Our Ref: IDL-1275-AW-02

RE: 25/01014/FP - Erection three storey building comprising 35no. retirement living apartments with associated communal areas, landscaping and parking following demolition of existing buildings. Land At Birchwood and Silverdale and Three Trees and Willow Close Old Charlton Road Hitchin Hertfordshire SG5 2AJ

We write in response to Anglian Water's holding objection regarding the proposed surface water discharge arrangements and the supporting evidence. The comments raised (shown in italics) are addressed below.

Figure 2

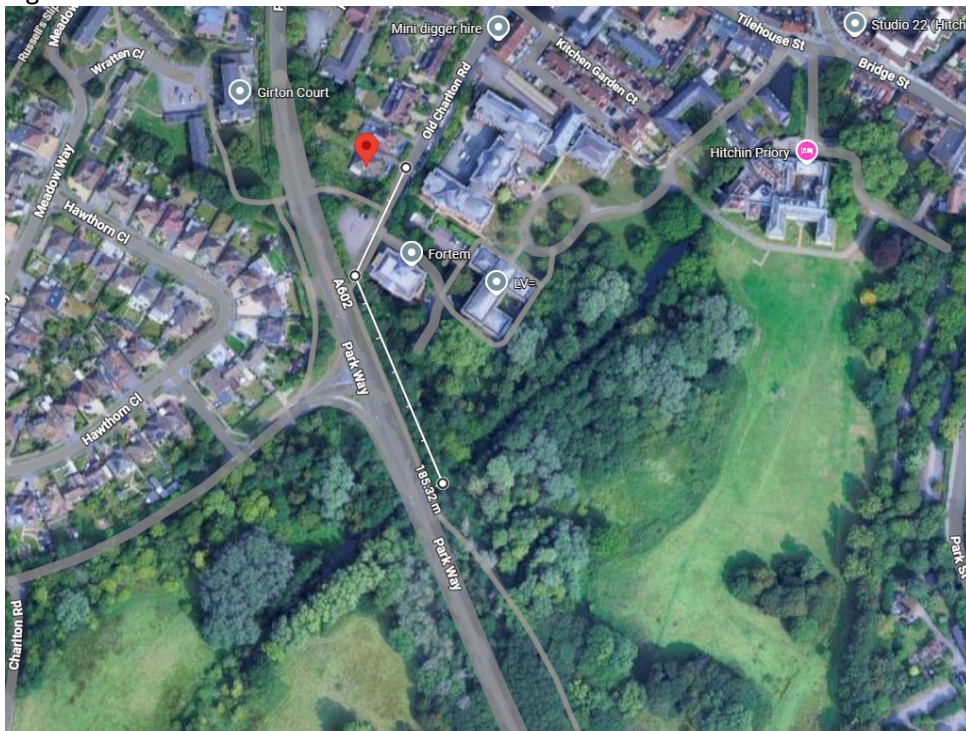
There is no infiltration testing provided in accordance with BRE Digest 365, there is not sufficient evidence of why the nearby watercourse cannot be utilised which is 130m from the development site and is not considered an unreasonable distance (higher up the hierarchy).

The nearest watercourse lies approximately 185 m south of the site. Refer to the Google map with the distance of the watercourse from the development site extract shown in Figure 1.

- Construction of a long off-site drainage run across several third-party land parcels.
- Negotiation of multiple easements and legal agreements, which are uncertain and time-intensive.
- Potential deep excavation to maintain gradient compliance over the full 185 m length.
- Acceptance of long-term maintenance responsibility for an extensive off-site system.

Due to these combined engineering, legal, and commercial constraints, discharge to the watercourse is neither practical nor viable within the SuDS hierarchy.

Figure 2

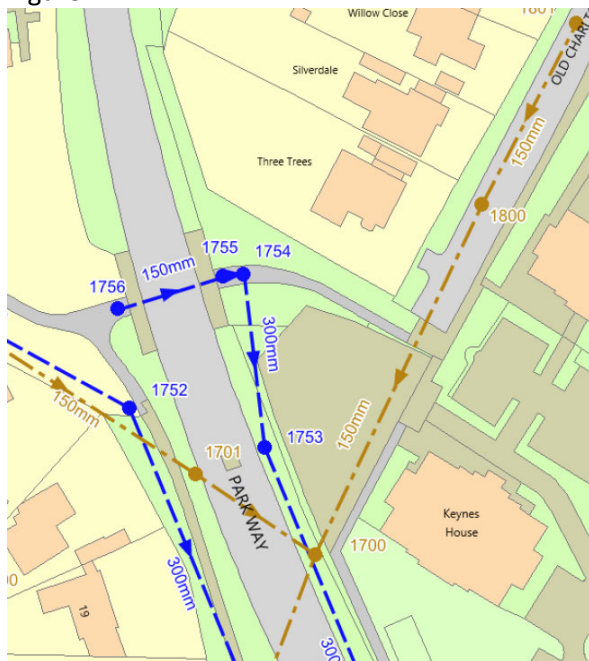
There is no evidence provided of an existing connection, just an assumption due to the close proximity of a public surface water sewer that it connects and at an unrestricted rate. Anglian Water require CCTV evidence of an existing connection without restriction or existing connectivity plan, and all higher hierarchy evidence before a rate will be assessed and considered.

There is no confirmed evidence of an existing designated surface water connection from the current buildings to the Anglian Water surface water sewer. Based on on-site observations, it is likely that roof and hardstanding runoff currently enters the foul sewer, which is typical of older developments.

- Surface water will be fully separated from the foul system.
- Discharge will be restricted to greenfield runoff rates, representing a substantial reduction compared with the current uncontrolled scenario.
- Surface water will discharge to AW manhole 1754, a suitable surface water sewer running south of the site. Refer to the Anglian Water sewer map extract shown in Figure 2.

This results in a significant betterment to the public sewer network by reducing hydraulic loading on the foul system, enhancing operational capacity and resilience under intensified rainfall conditions.
